Subject: BP Gas Station (Former Clark Gas Station # 562)
4751 N. Santa Monica Blvd., Milwaukee, WI

BRRTS #: 03-41-589630 Start: 04-20-2022 End: Active/Open

Addendum to the Site Investigation Work Plan (SIWP)

Figure 4: Benzene Concentration (ppb) at Closure of BRRTS # 03-41-000450

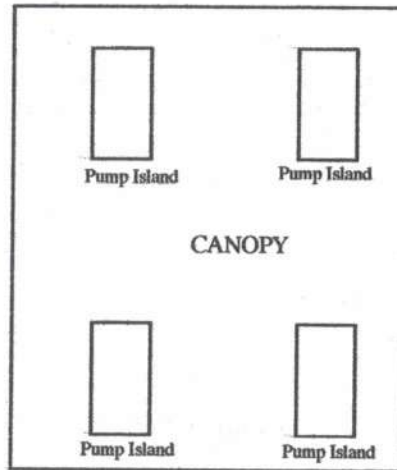
1. Submit a figure showing the location of former area of the residual soil and groundwater contamination of the closed BRRTS # 03-41-000450 in relation to the proposed soil borings/monitoring wells for the open BRRTS # 03-41-589630 and location of the GEC-TSSA soil samples exceeding the NR 720 residual contaminant levels (RCLs).
2. Provide a narrative on how the locations of the four soil borings/wells will aid to determine the degree and extent of the contamination from the recent release, evaluate the new discharge in relation to the residual contamination from the closed BRRTS # 03-41-000450, and explain the applicability of the location of the proposed soil boring at 30 feet away from S-1 and S-11 on the scaled figure.

The four former abandoned sump wells (S-1 through S-4), MW-1, and Q-1 appear to be in the new release area (BRRTS # 03-41-589630). The approximate locations and concentrations at the time of closure have been shown on **Figure 4**.

Figure 5: Locations of Proposed Soil Borings and Monitoring Wells

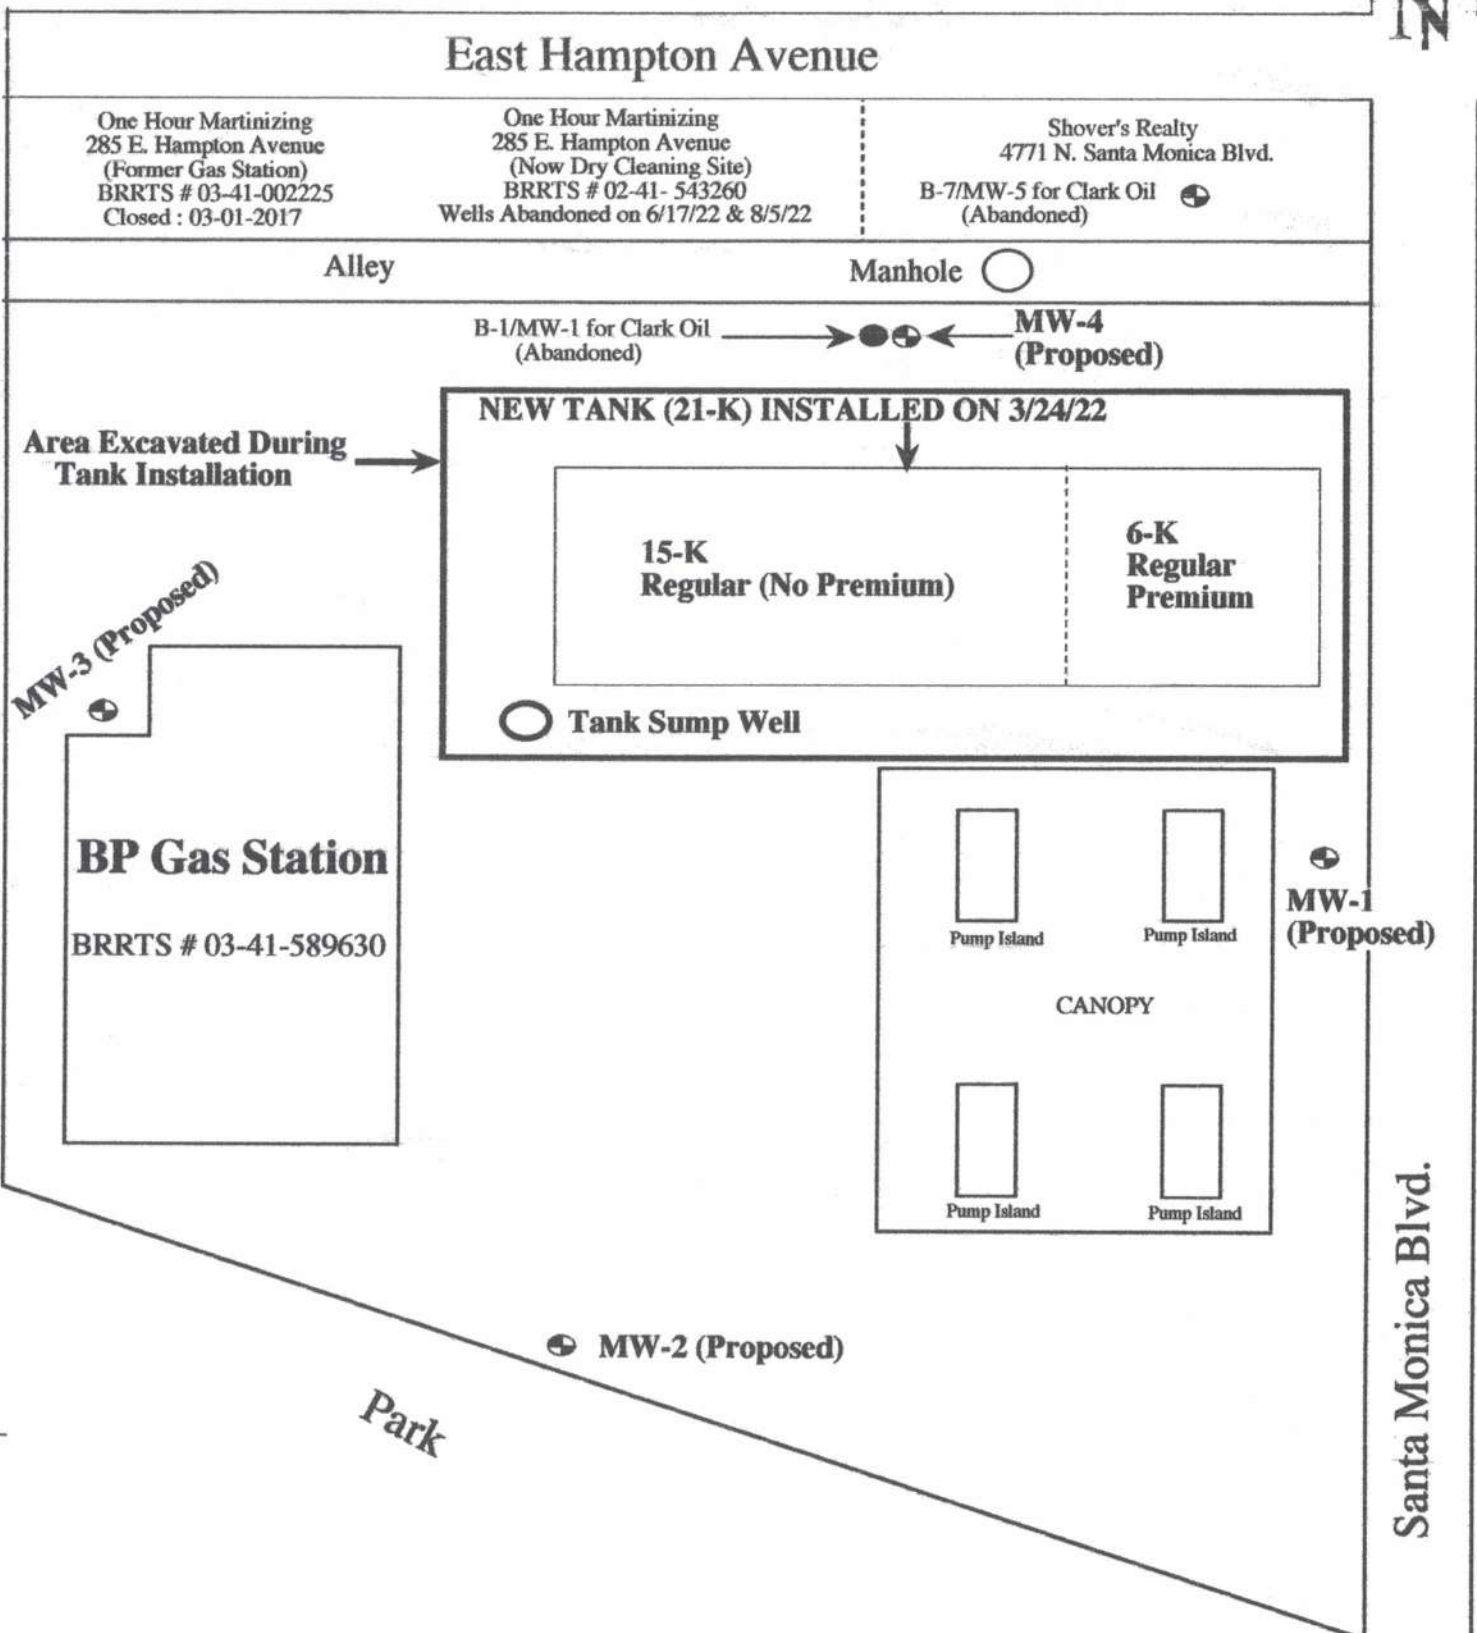
3. Provide the soil disposal document as noted in the TSSA report, and
4. Installation of the proposed well MW-4 at the location of the former monitoring well MW-1

OM Enterprises, Inc. proposed to advance four soil borings/monitoring wells as shown on **Figure 5** and summarized below.

The monitoring well MW-1 has been proposed in the landscape area. The proposed well MW-1 is located very close to the NE pump island (S-11 sample location). The well will be moved to the north to cover the sample location of S-1. If the well is contaminated, we may consider drilling hole in the public right of way.

The monitoring well MW-2 has also been proposed in the landscape area. We believe that the well define the plume. If the plume is not defined, we may consider drilling in the right of way of the county park.

The monitoring well MW-3 has been proposed in the asphalt area. There is no room to install a well between the building and canopy. There is a sump well (~ 15 feet deep) at the southwest corner of the tank bed. The depth to the groundwater in the sump well was ~ 10 feet below the grade in August 2022. If the sump well is contaminated, MW-3 would be helpful to define the plume.

14. The Wisconsin Administrative Code § NR 141.25 (2) (d) requires cutting the well casing at least thirty inches below the grade. The PVC has not been cut. The PVC is filled with the bentonite. There is no bentonite surrounding the well casing. The driller will pull the PVC pipe; remove the residual bentonite, if any; and install the monitoring well MW-4 at the same location.
